CUNNANE STRATTON REYNOLDS

Ref: 22159 / RF

**RE: Planning Ref SD22A/04010 - Site at Scholarstown House, Scholarstown Road, Dublin 16
Additional Information Request – Landscape Issues**

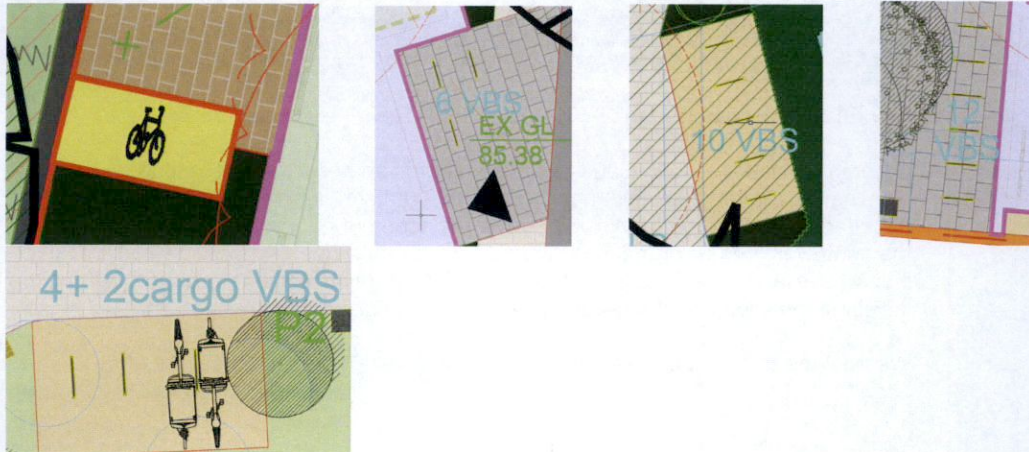
(j) It is not clear where all the external bicycle parking spaces are, in order to meet the 183 no. total stated. The applicant is requested to clarify this.

(j): The previous submitted landscape plan had shown the external cycle parking spaces but these were not clearly indicated on the plan's legend. The revised landscape plan legend has been updated to show these spaces, with several external cycle parking spaces found throughout the plan as highlighted in the extracts below.

Layout Changes - Landscaping

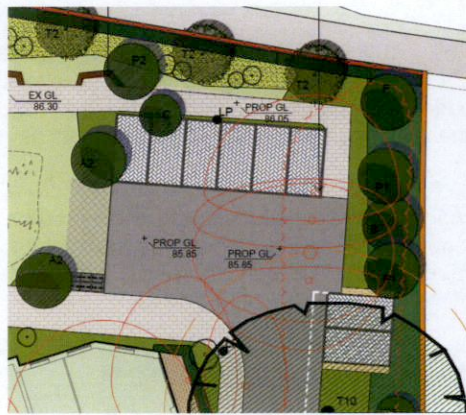
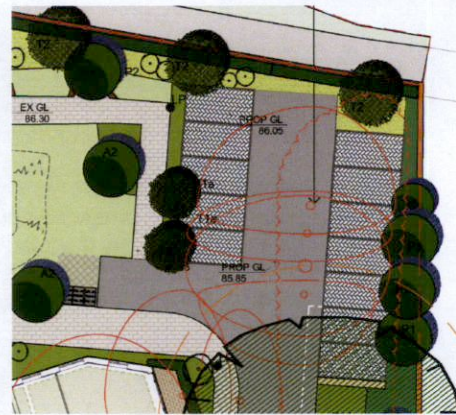
The proposed site layout changes include a revision to the area of carparking to the northern boundary to allow for 4 additional carparking spaces. This has resulted in reconfiguring some areas of the soft and hard landscaping in this corner of the site to contain these additional spaces. The redesign has resulted in some loss of shrub and meadow grass cover on the boundary edge. However, the reduced road surface area has helped to slightly increase the width of the eastern end of the previously proposed grassed open space by approx. 21m². The variation between the parking layout in the submitted and revised layouts is indicated below.

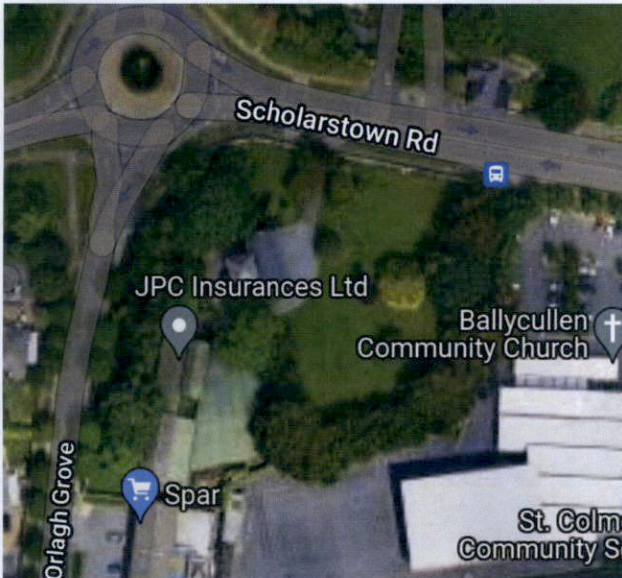
As discussed at the pre-planning meeting for the below site, Scholarstown House, to obtain access to the site and comply with traffic sightline requirements, the proposed development would unfortunately require the removal of one street tree, (see attached for location). There are 5 trees shown on the aerial view but there are only 4 currently, (see attached photo).

Do you have an objection to the remove of this tree? We can put in a replacement tree on the proposed development or on Orlagh Grove in one of the locations indicated on the attached.

Ideally we would prefer if this street tree was retained however if it requires removal in order to provide access and sightlines then we can accept this once suitable replacement tree planting is provided as suggested below (we would look for the two replacement trees to compensate for the loss of this mature street tree) and the other street trees in the grass margin are retained and protected by suitable tree protection fencing and not impact by the proposed development works.

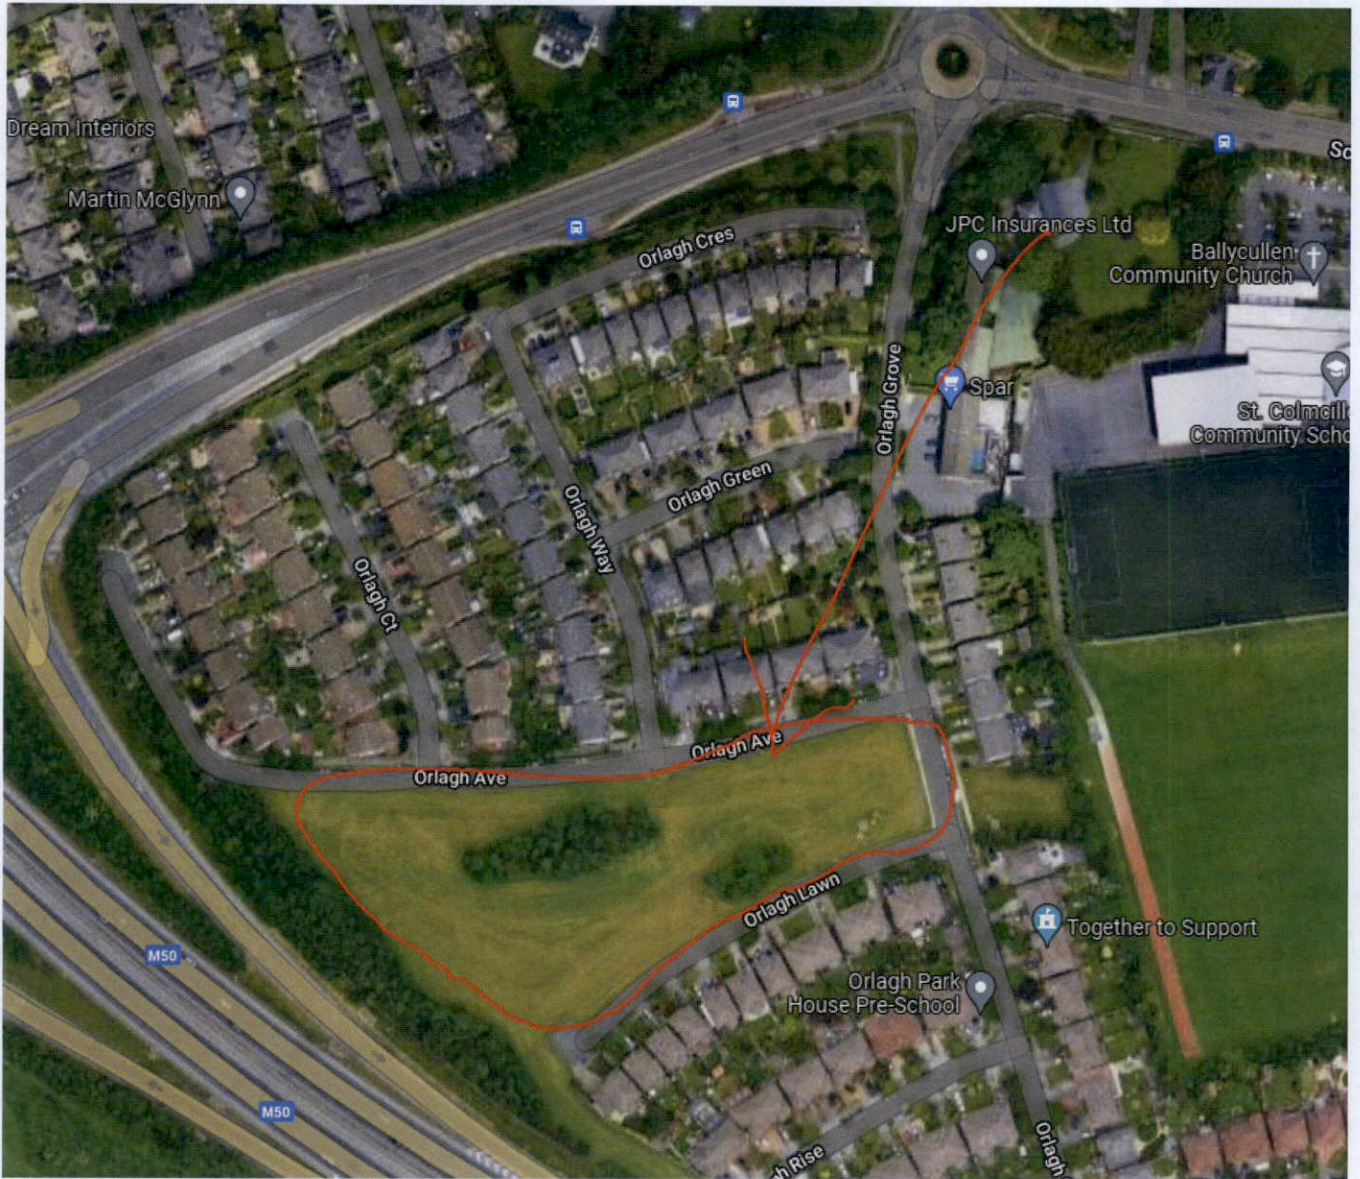
In order to meet this requirement we would be agreeable for this shortfall (134 no.) in trees provided within the development to be provided for off site as a mini-woodland on a nearby open space such as the one located in Orlagh Estate;

See below possible location for mini woodland planting (to be agreed):
